H11621

NOAA FORM 76-35A	
U.S. DEPARTMENT OF COMMERCE NATIONAL OCEANIC AND ATMOSPHERIC ADMINISTRATION NATIONAL OCEAN SURVEY	
DESCRIPTIVE REPORT	
Type of Survey	Hydrographic
Registry No.	H11621
LOCALITY	
State	Alabama
General Locality	Mississippi Sound
Sub-locality	Grand Bay to Petit Bois Pass
2006	
CHIEF OF PARTY Dean Moyles FUGRO PELAGOS, Inc	
DATE	LIBRARY & ARCHIVES

<p>REMARKS: The purpose of this work is to provide NOAA with modern debris mapping survey in the area of Mississippi Sound from Grand Bay to Petit Bois Pass.</p> <p>ALL TIMES ARE RECORDED IN UTC.</p> <p><i>Remarks in red, bold italics were made during AHB processing of this survey.</i></p> <p>FUGRO PELAGOS INC 3738 RUFFIN ROAD SAN DIEGO, CA 92123</p>

Figure 3 H11621 Chart Comparison 1

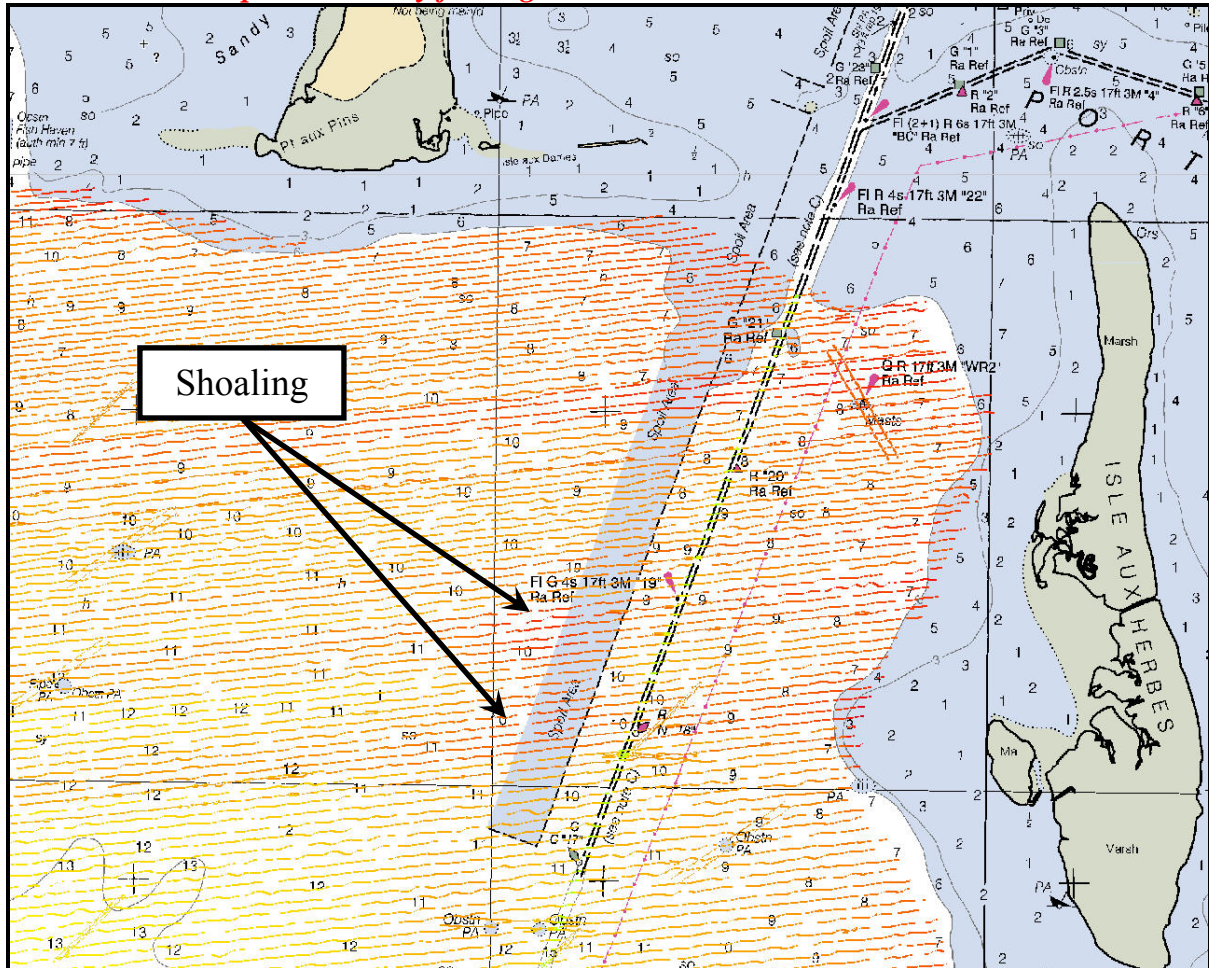
- Hydrographic survey H11621 revealed a depth of 5 feet in the vicinity of a 10 foot sounding on chart 11374 located at 30° 20' 14.98" N, 088° 17' 56.75" W. This area was surveyed with single beam sonar. The shoaling is centered in the area depicted

below. **Do not concur. Ten foot present survey depths found in vicinity. Update chart with present survey findings.**

Figure 4 H11621 Chart Comparison 2

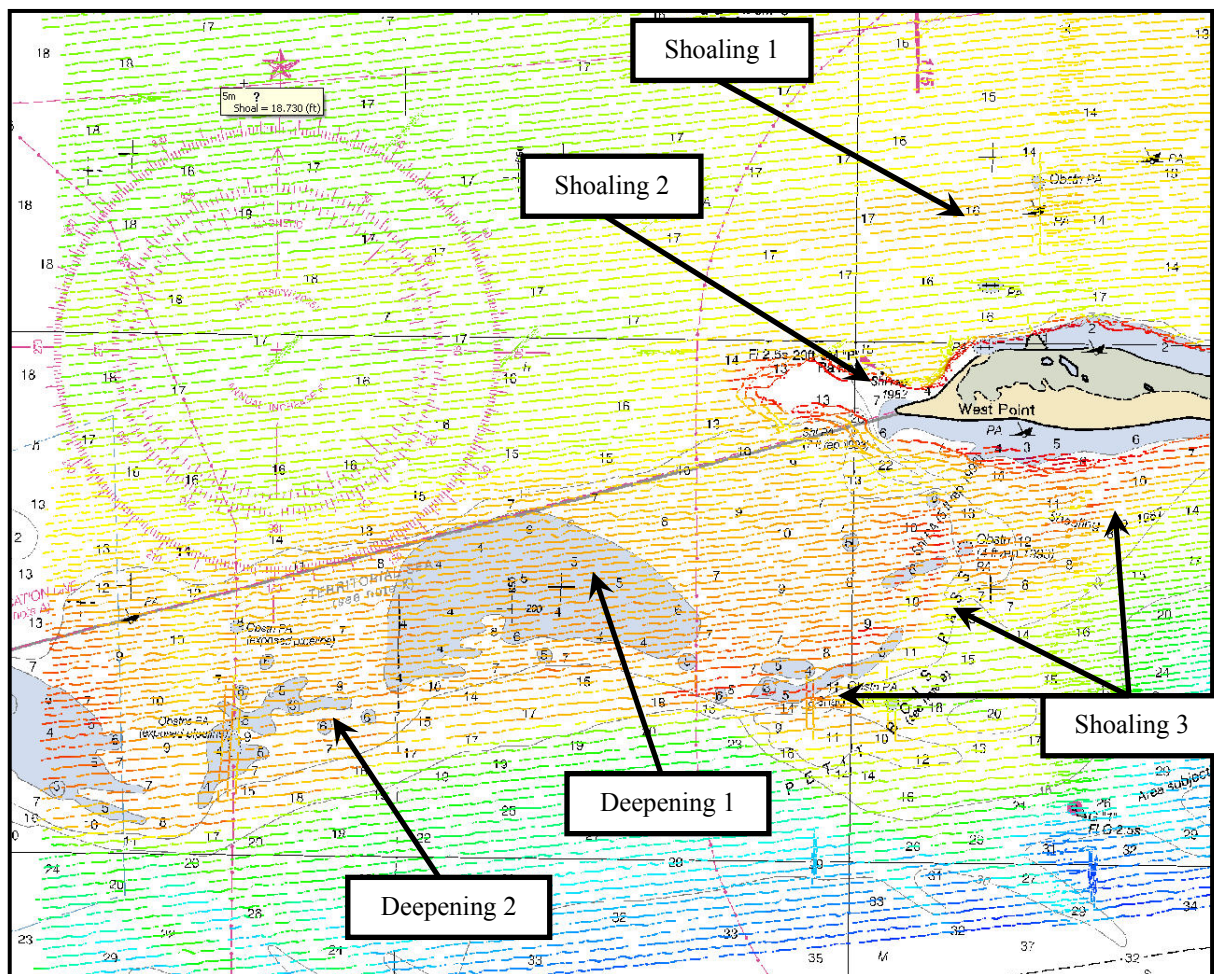
- Hydrographic survey H11621 revealed a depth of 4-3 feet in the vicinity of a 10 foot sounding on chart 11374 located at 30° 12'56.61" N, 088° 19'53.12" W. This area was surveyed with single beam sonar. The shoaling is centered in the area depicted below as Shoaling 3. **Concur. Update area with present survey data.**

- Hydrographic survey H11621 revealed a depth of 10 feet in the vicinity of a 4 foot sounding on chart 11374 located at 30° 13'03.61" N, 088° 21'27.35" W . This area was surveyed with single beam sonar. The deepening is centered in the area depicted below as Deepening 1. **Concur. Update area with present survey data.**
- Hydrographic survey H11621 revealed a depth of 10 feet in the vicinity of a 3 foot sounding on chart 11374 located at 30° 12'31.88" N, 088° 22'38.26" W . This area was surveyed with single beam sonar. The deepening is centered in the area depicted below as Deepening 2. **Concur. Update area with present survey data.**

Figure 1.1.1

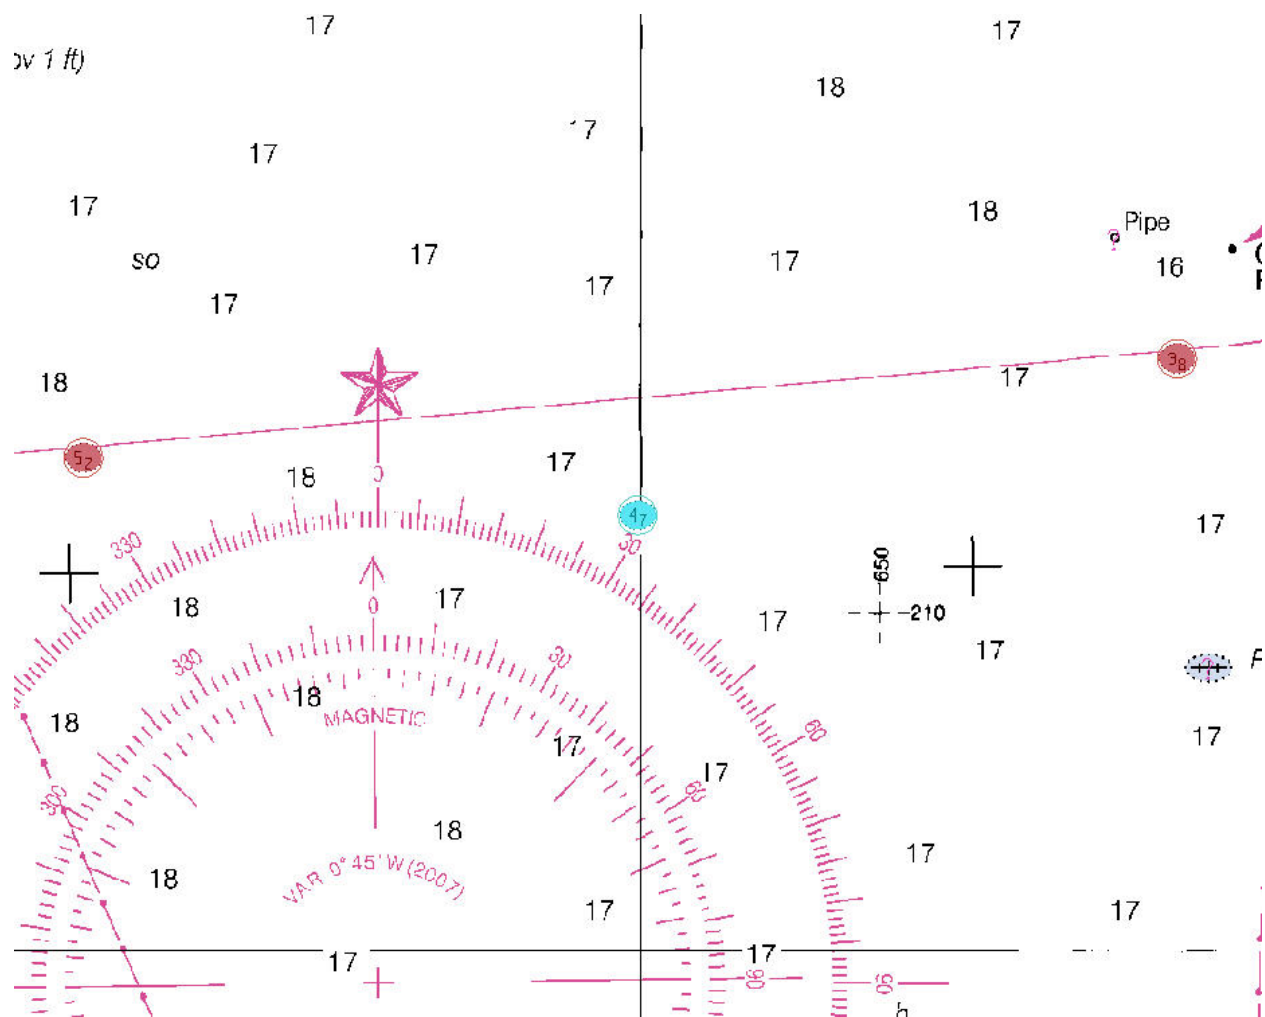
Recommend charting 15ft obstruction reported 2006. ***Concur. Add a dangerous submerged obstruction symbol and the notation 15 ft rep 2006.***

Figure 1.2.1

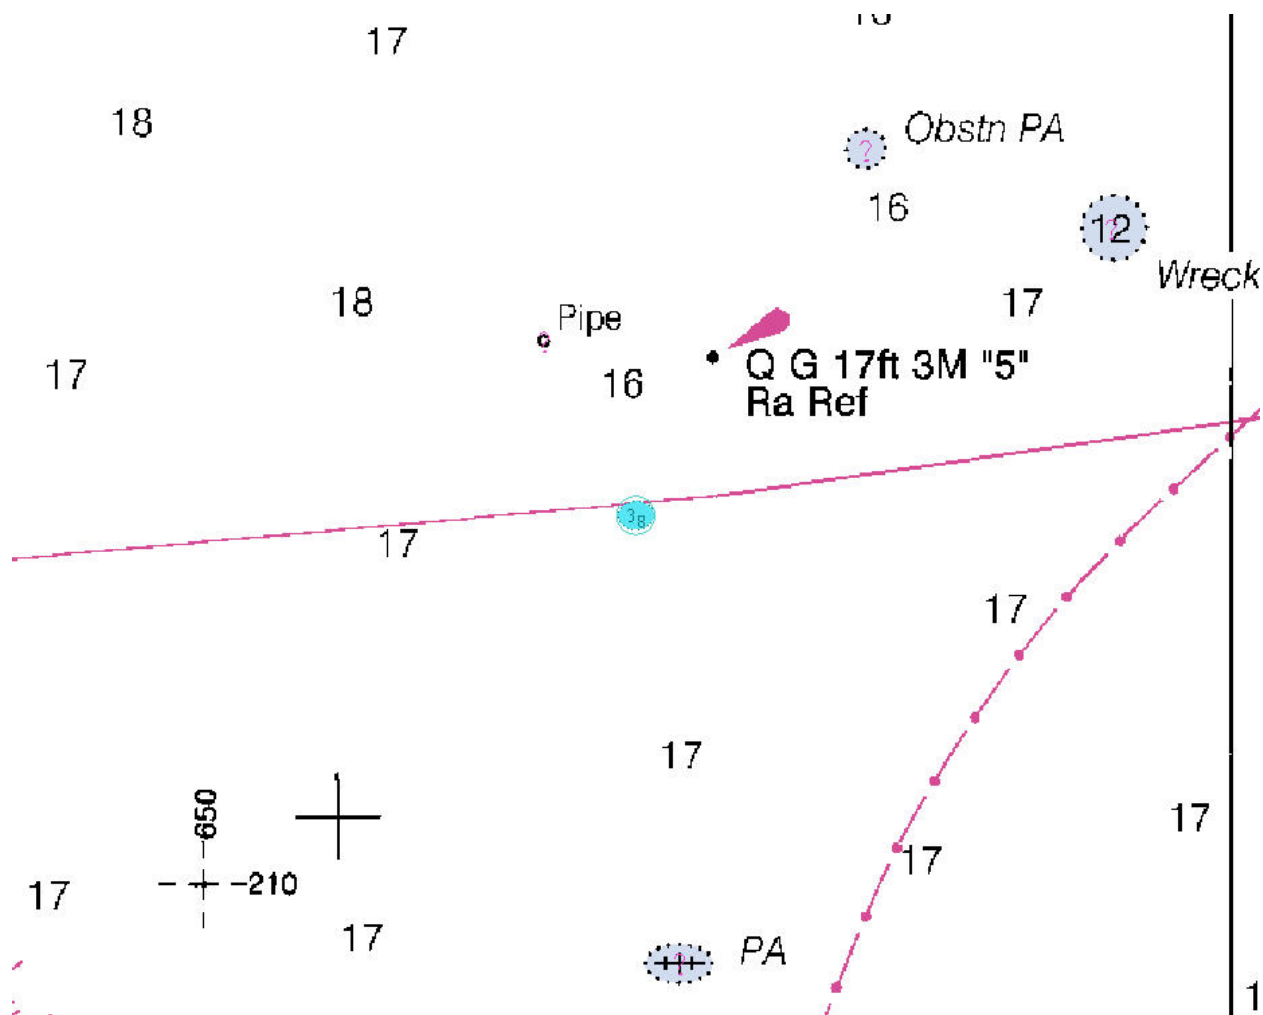
Recommend charting 12ft obstruction reported 2006. ***Concur. Add a dangerous submerged obstruction symbol and the notation 12 ft rep 2006.***

Figure 1.4.1

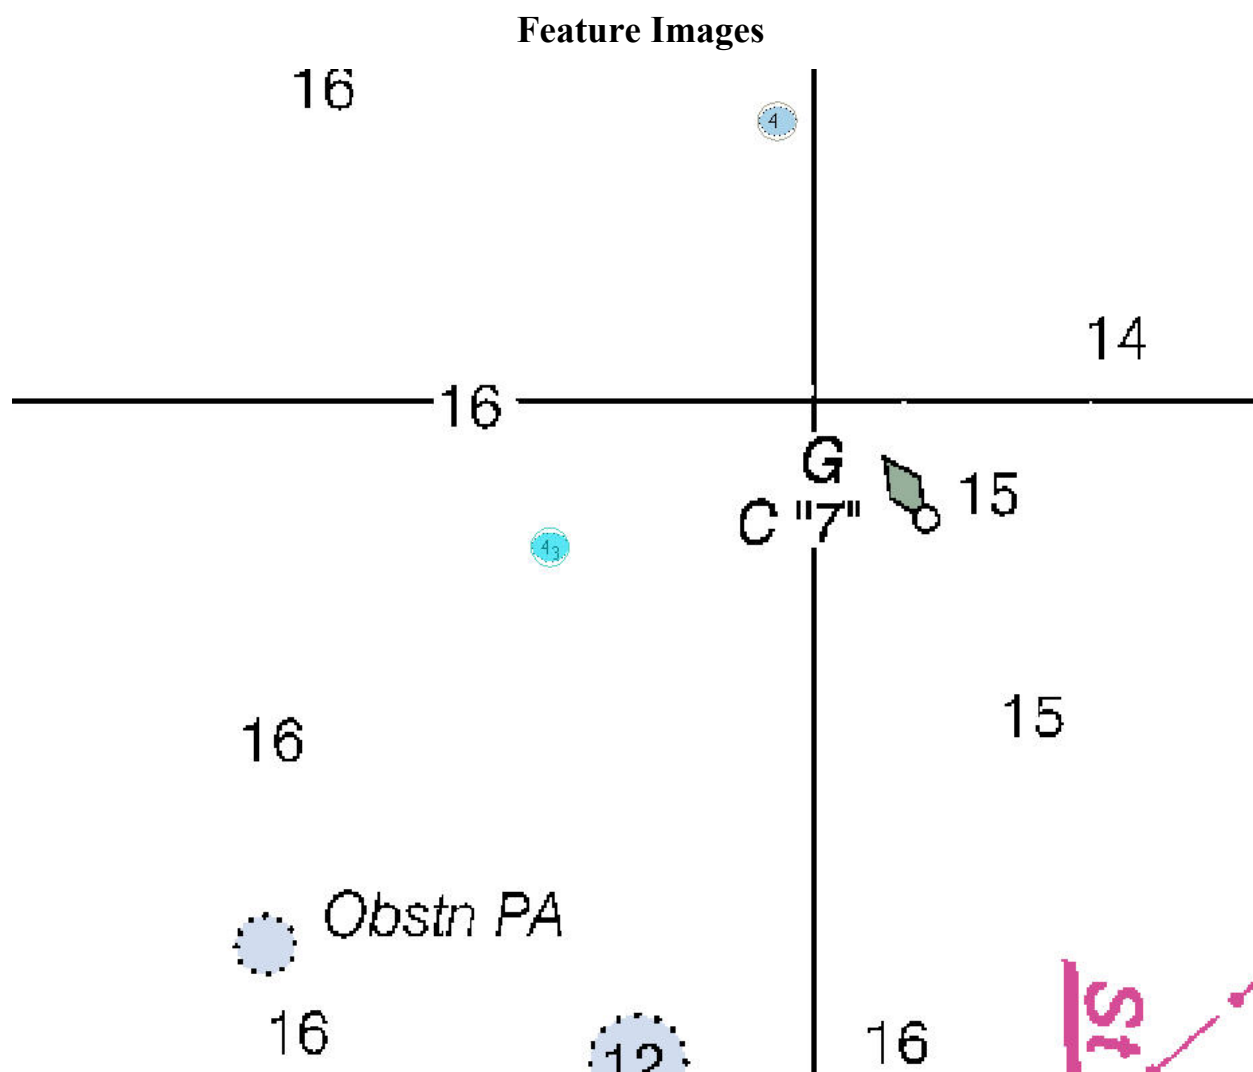
Recommend charting 14ft obstruction reported 2006. **Concur. Add a dangerous submerged obstruction symbol and the notation 14 ft rep 2006**

Figure 1.6.1

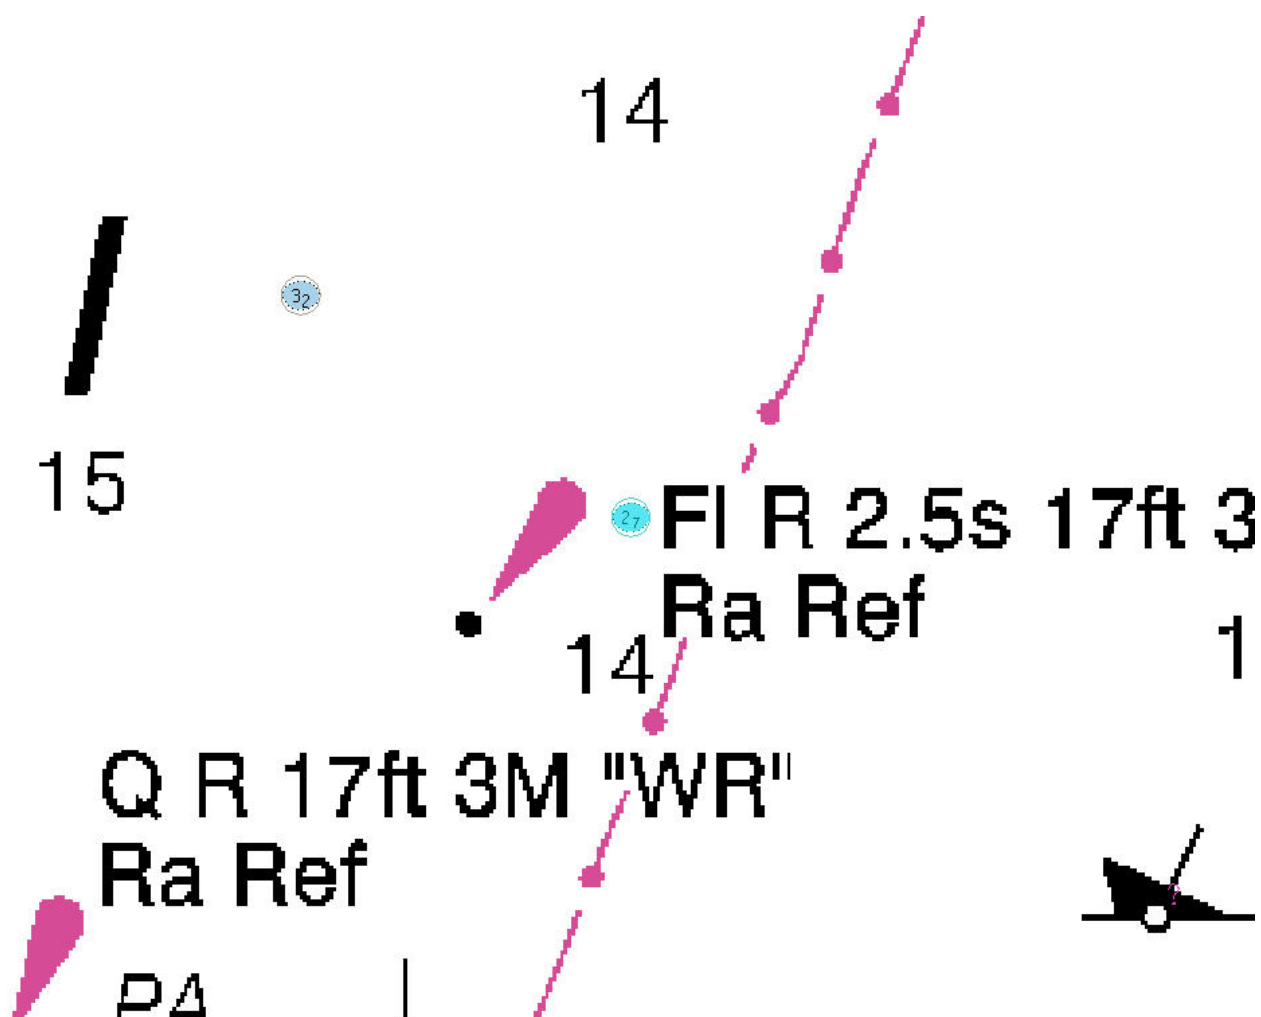
Recommend charting 9ft obstruction reported 2006. *Concur. Add a dangerous submerged obstruction symbol and the notation 9 ft rep 2006*

Figure 1.7.1

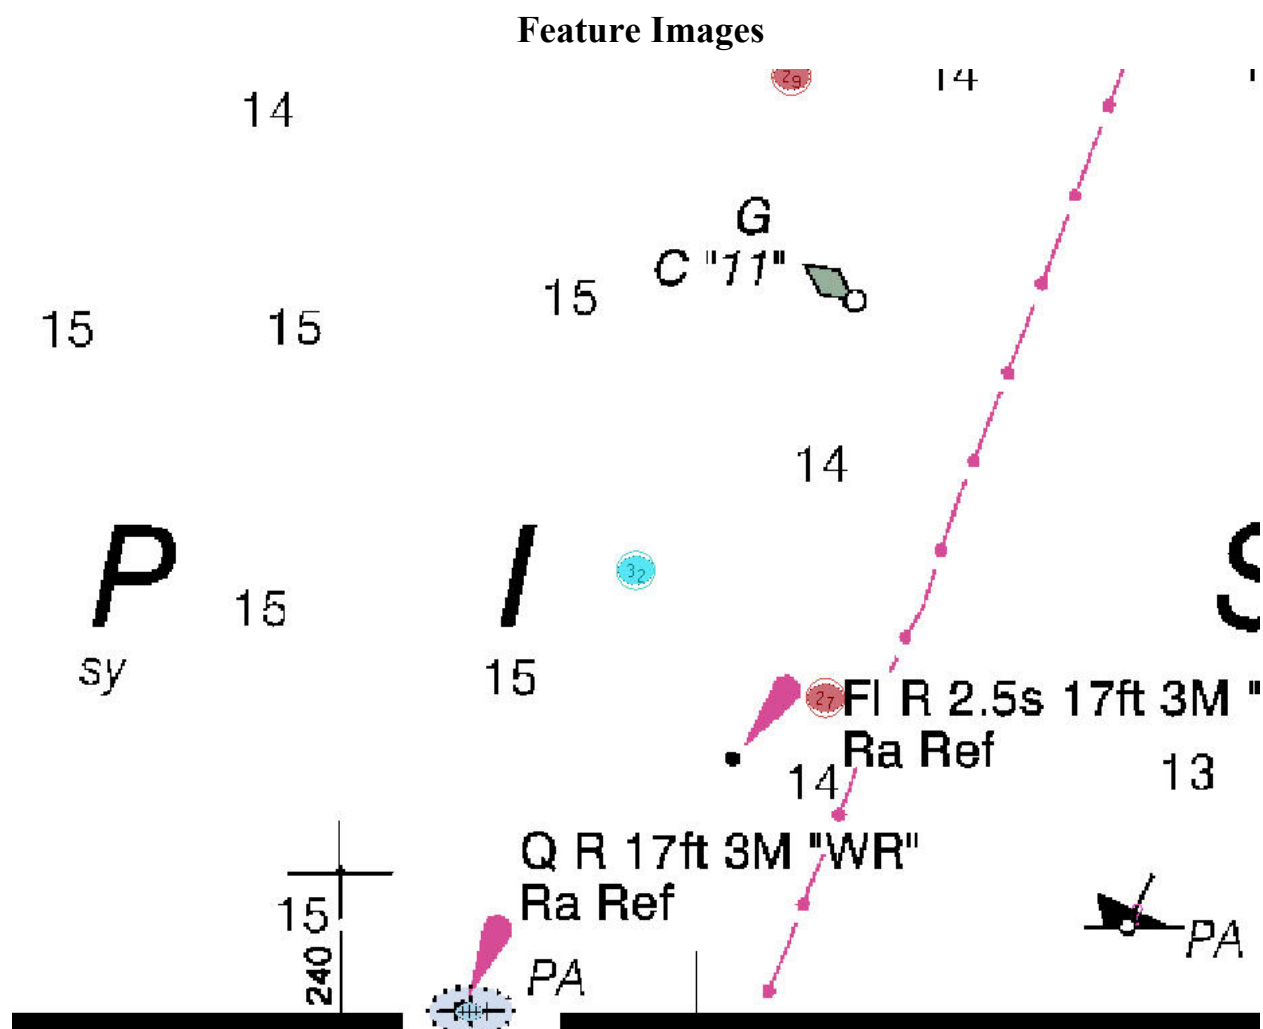
Recommend charting 10ft obstruction reported 2006. *Concur. Add a dangerous submerged obstruction symbol and the notation 10 ft rep 2006.*
